HISTORIC AND DESIGN REVIEW COMMISSION

HDRC CASE NO: 2022-432
ADDRESS: 318 FLORIDA ST
LEGAL DESCRIPTION: NCB 3010 BLK 8 LOT 5
ZONING: R-6, H
CITY COUNCIL DIST.: 1
DISTRICT: Lavaca Historic District
APPLICANT: Anita Alvarado
OWNER: MARTINEZ REYES D JR &
TYPE OF WORK: Partial demolition, addition
APPLICATION RECEIVED: July 24, 2022
60-DAY REVIEW: Not applicable due to City Council Emergency Orders
CASE MANAGER: Jessica Anderson

The applicant requests a Certificate of Appropriateness for approval to demolish the rear porch and construct an approximately 600-square-foot rear addition.

1 EXISTING / DEMOLITION FLOOR PLAN

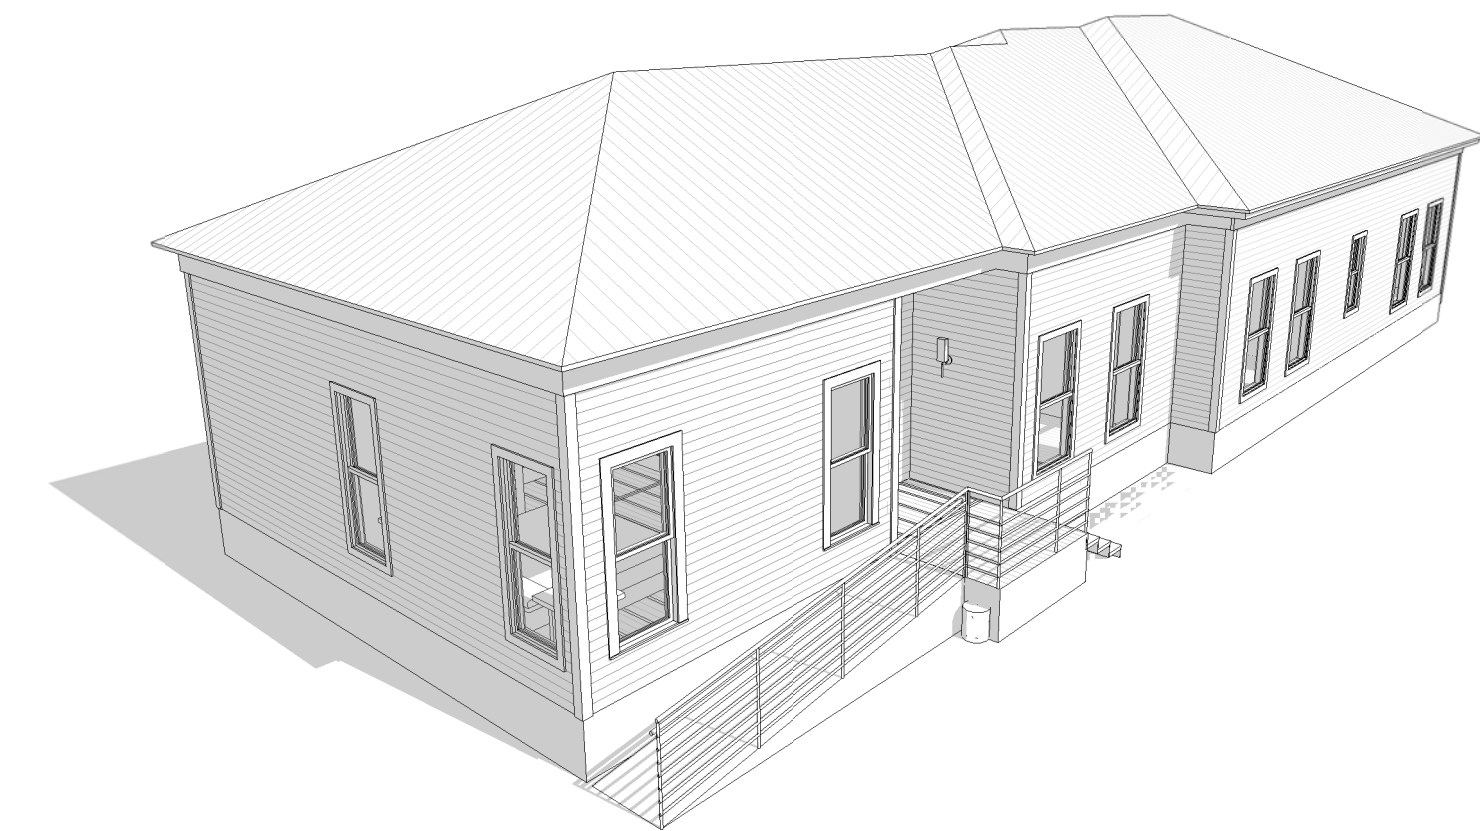
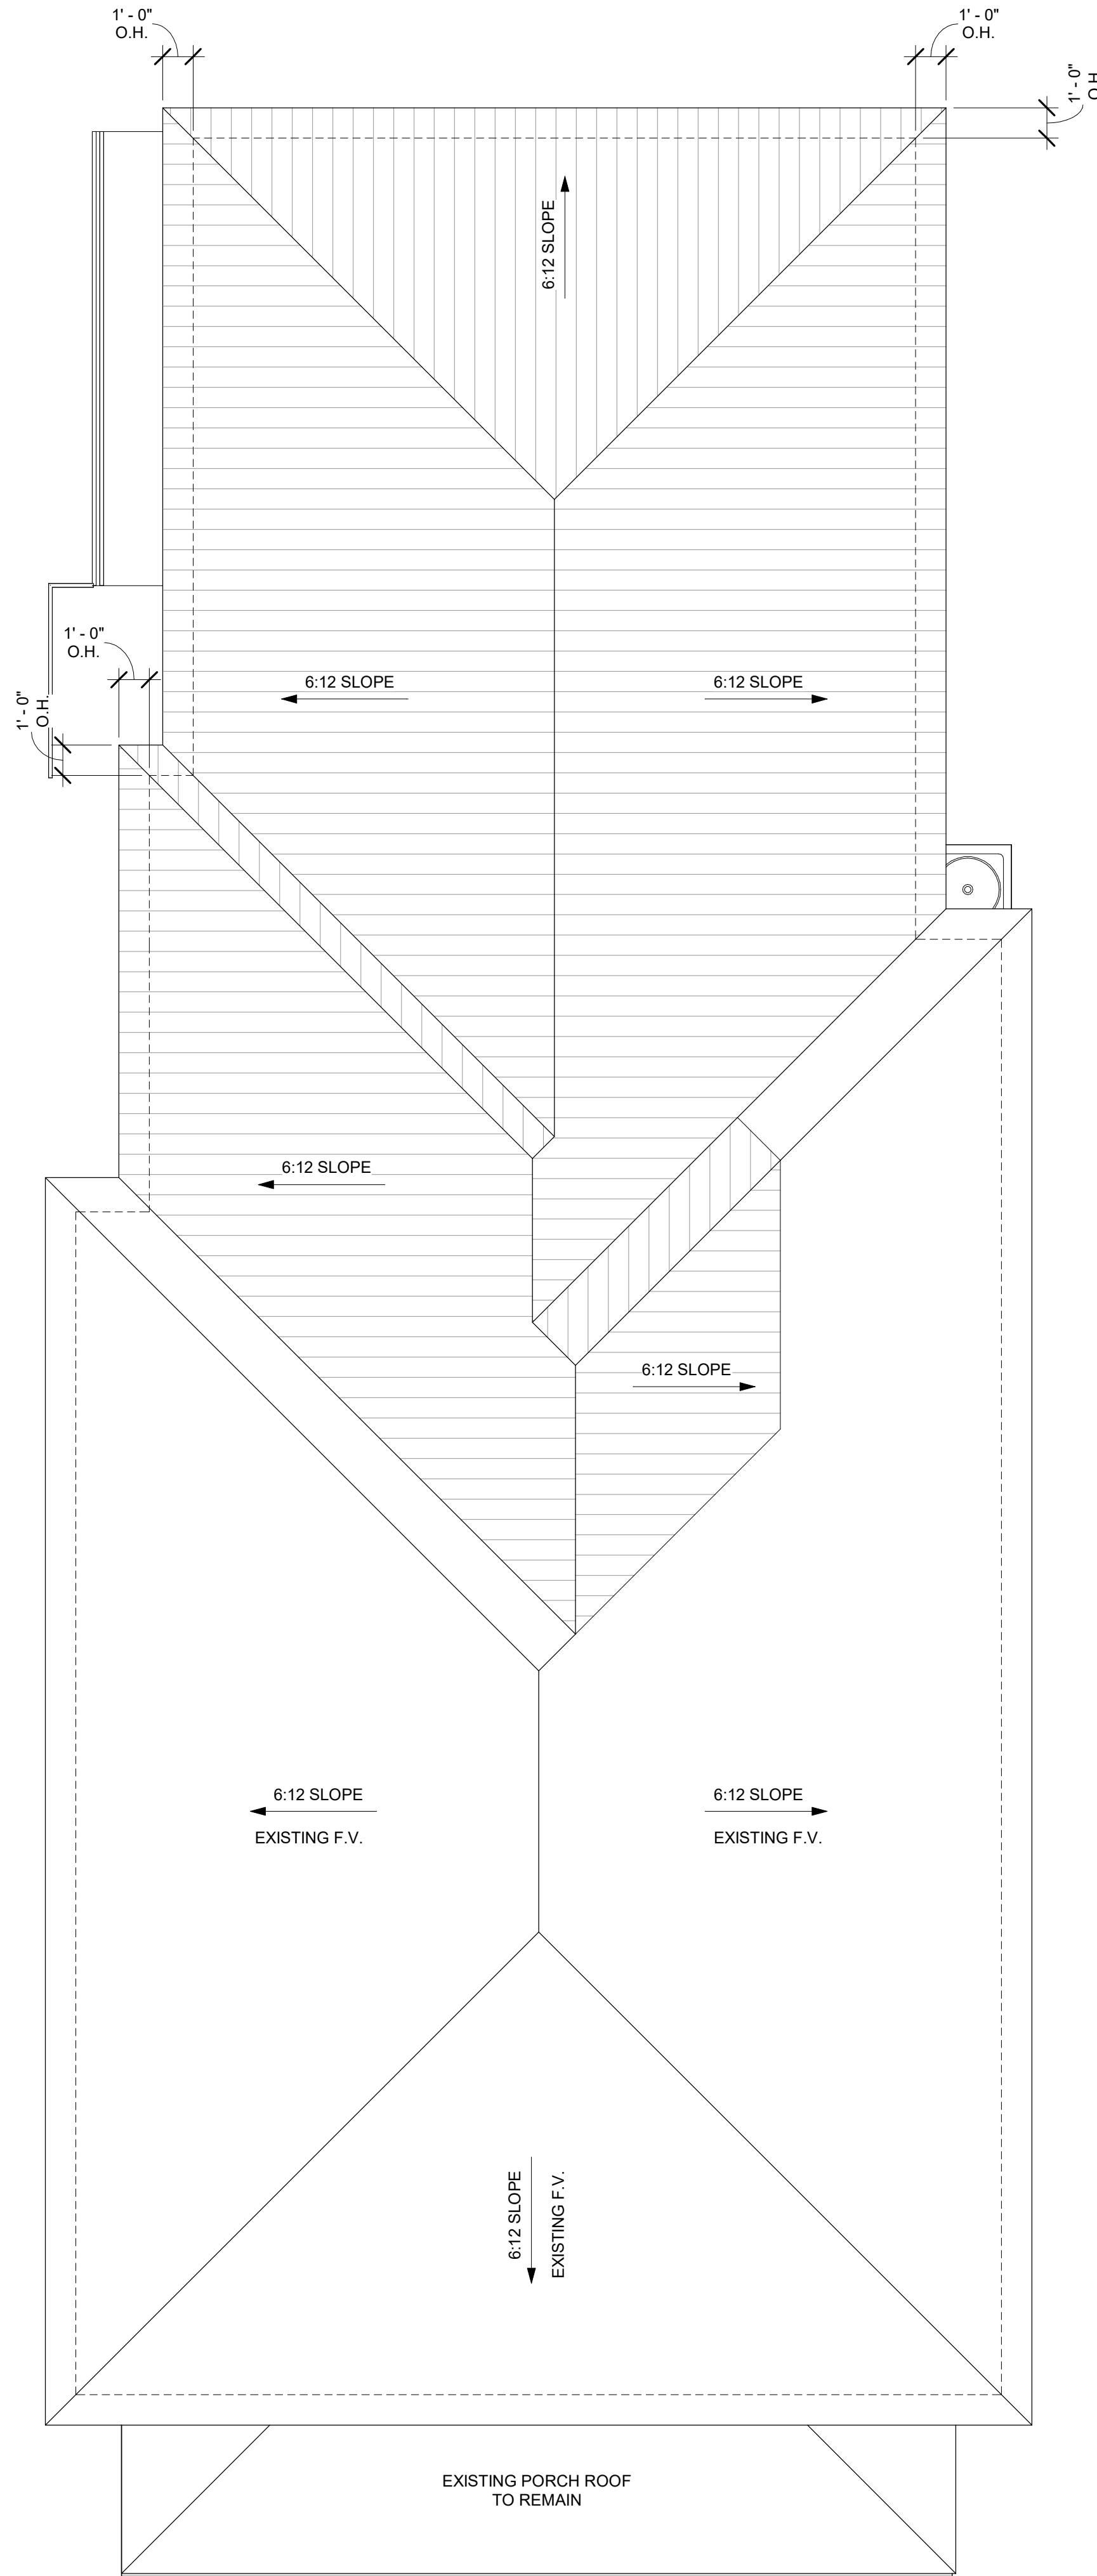
- b. **DEMOLITION OF REAR PORCH:** The applicant requests approval to demolish a one-story porch at the rear of the house. The house first appears on Sanborn Fire Insurance maps along with a partial-width rear porch in 1912. The partial-width porch remained through the house's last appearance on these maps in 1951. Staff was unable to determine when the rear porch was extended and infilled. Because the current conditions of the rear porch are not original, staff finds the rear porch demolition generally appropriate.

Staff recommends approval of demolition of the rear porch based on finding b.

5 WEST ELEVATION
1/4" = 1'-0"

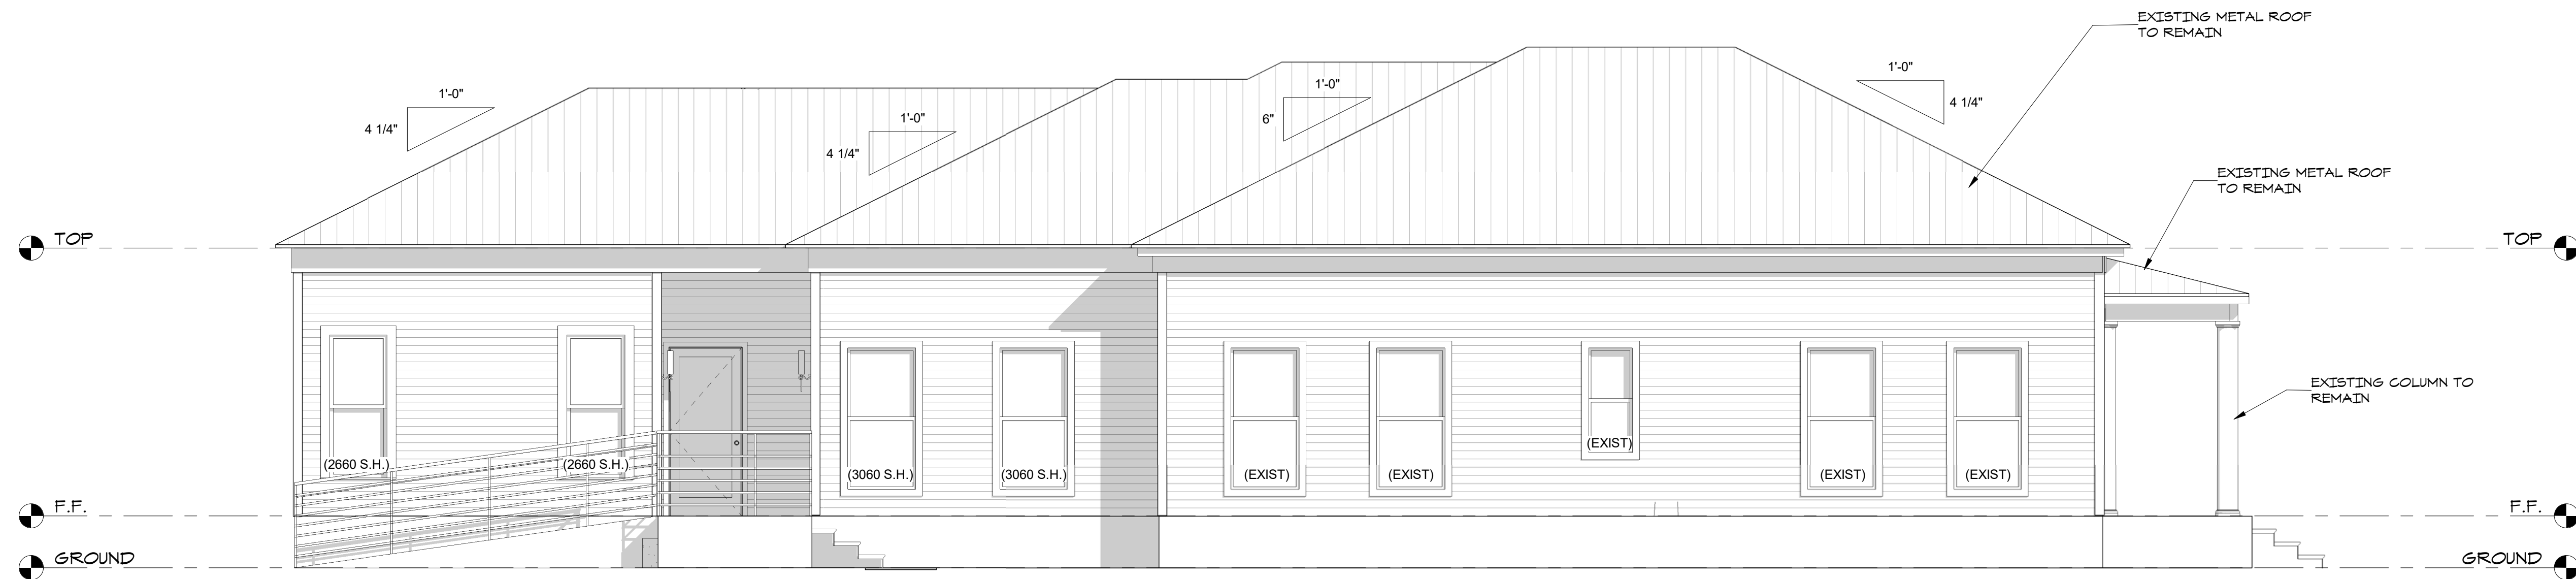
- f. **ADDITION (WINDOWS):** The applicant proposes using wood-frame one-over-one single-hung windows that match existing windows in both material and dimensions, with the exception of one fixed-glass window on the west elevation. Standard Specifications for Windows in Additions and New Construction state that new windows on additions should relate to the windows of the primary historic structure in terms of materiality and overall appearance and that windows should feature traditional dimensions and proportions as found within the district. Proposed one-over-one windows meet these standards; the fixed-glass window on the west elevation does not conform to staff standards.

- g. **ADDITION (DOOR):** The applicant proposes an inset door on the west elevation but did not provide specifications for the proposed door. The new doors should match the Folk Victorian house in style, such as half-lite wood door, commonly found on secondary entrances of Folk Victorian homes.

- i. That the applicant proposes a door for the west elevation that matches the Folk Victorian house in style, such as a half-lite wood door, commonly found on secondary entrances of Folk Victorian homes.
- ii. That the design for the west porch incorporate a style of railing more in keeping with the architectural style of the original structure, namely one with vertical balusters.

3 EAST ELEVATION
1/4" = 1'-0"

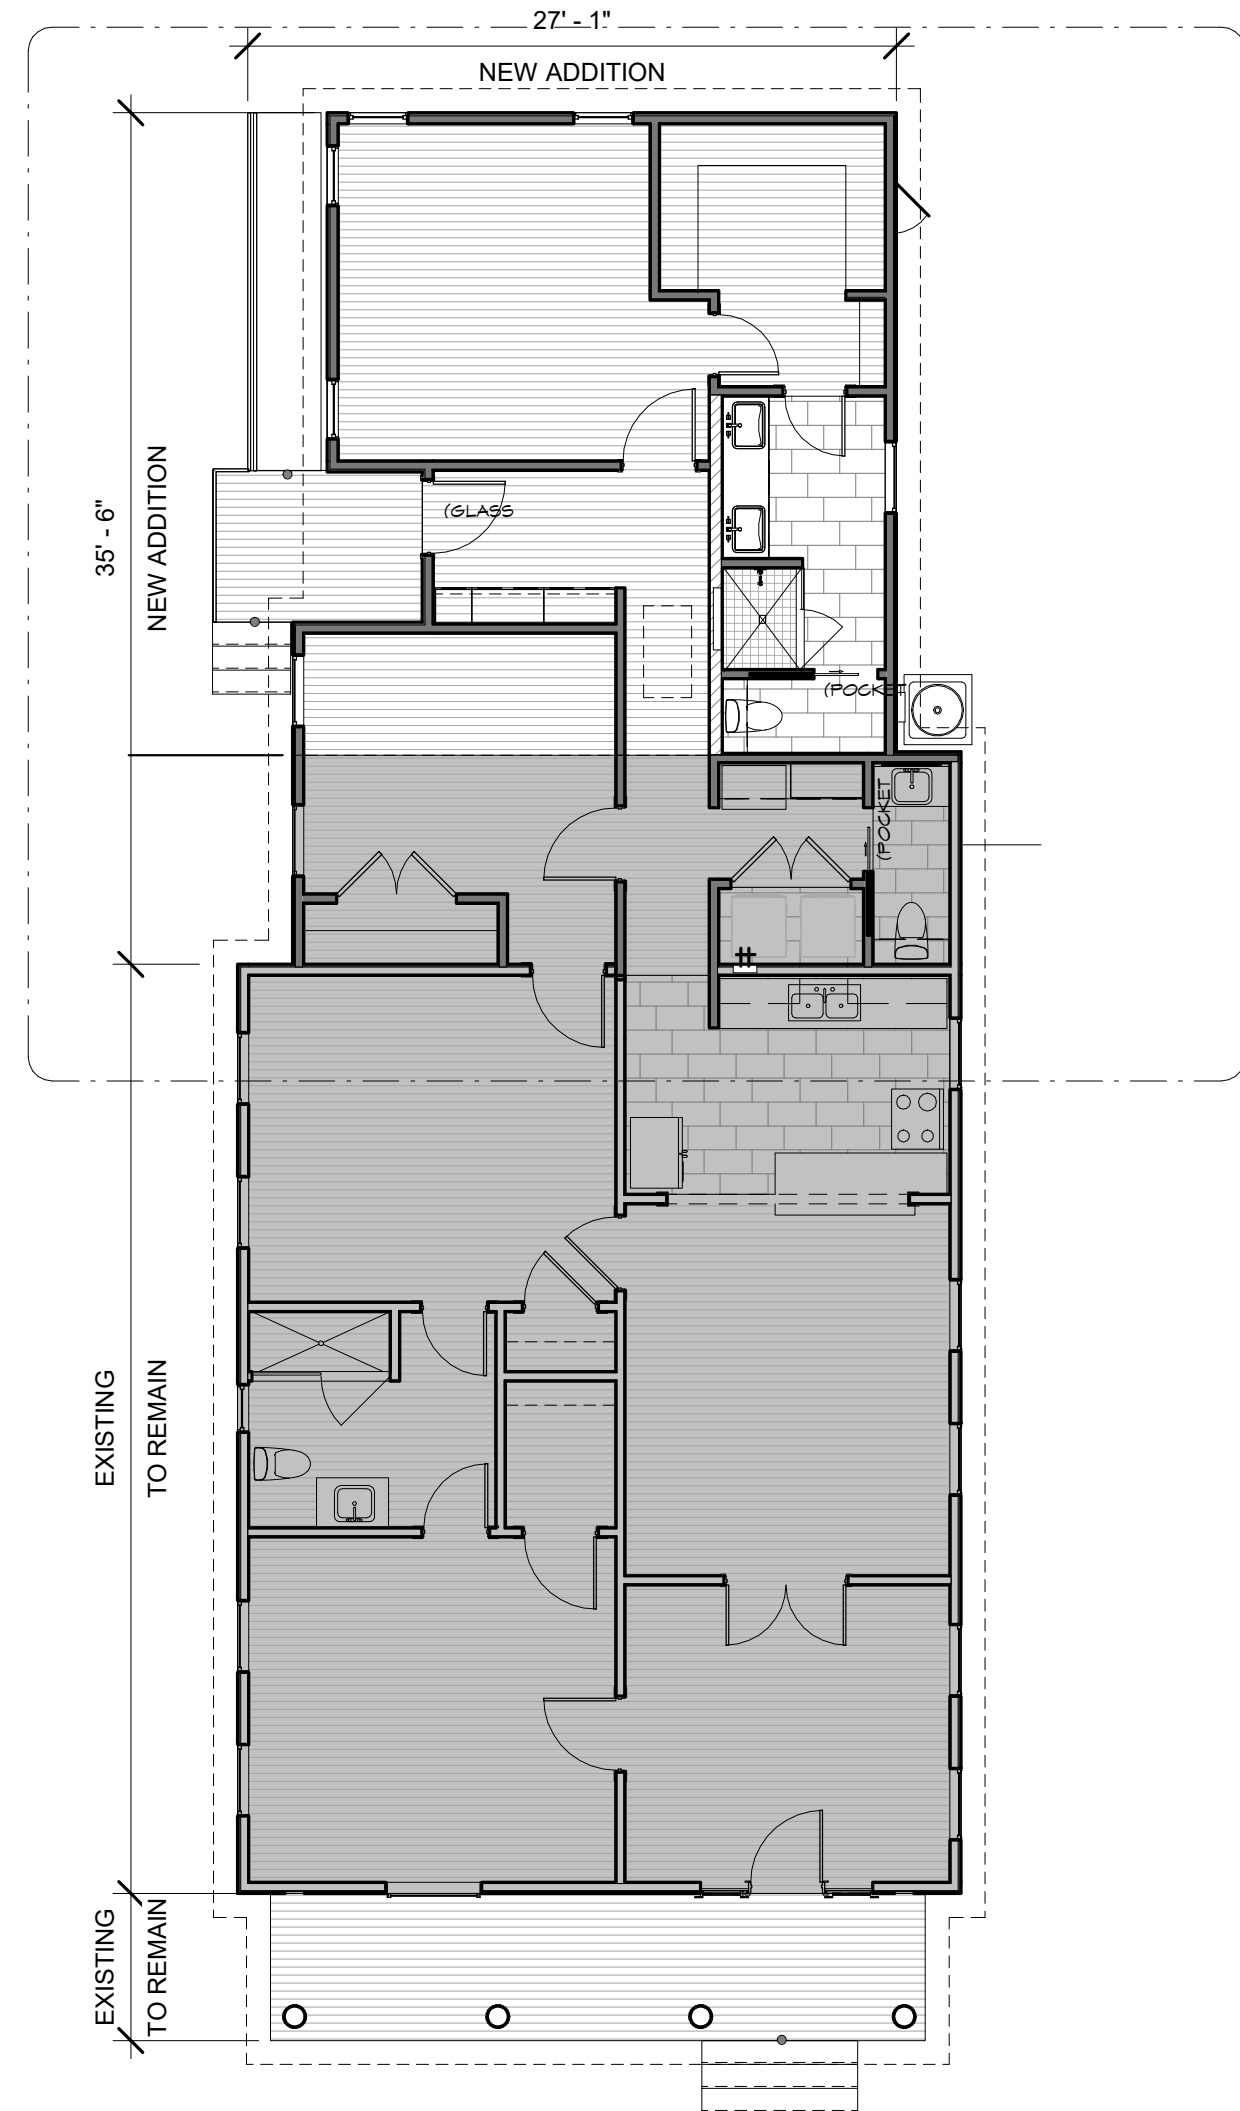
- h. **ADDITION (ARCHITECTURAL DETAILS: RAILING):** The applicant proposes a wood-frame porch and ramp on the east side of the addition with a horizontally-oriented railing. Guideline 4.A.ii for Additions states that additions should incorporate architectural details that are in keeping with the architectural style of the original structure. Details should be simple in design and compliment the character of the original structure. Staff finds the deck is generally appropriate, but that the applicant should choose a style of railing more in keeping with the architectural style of the original structure.
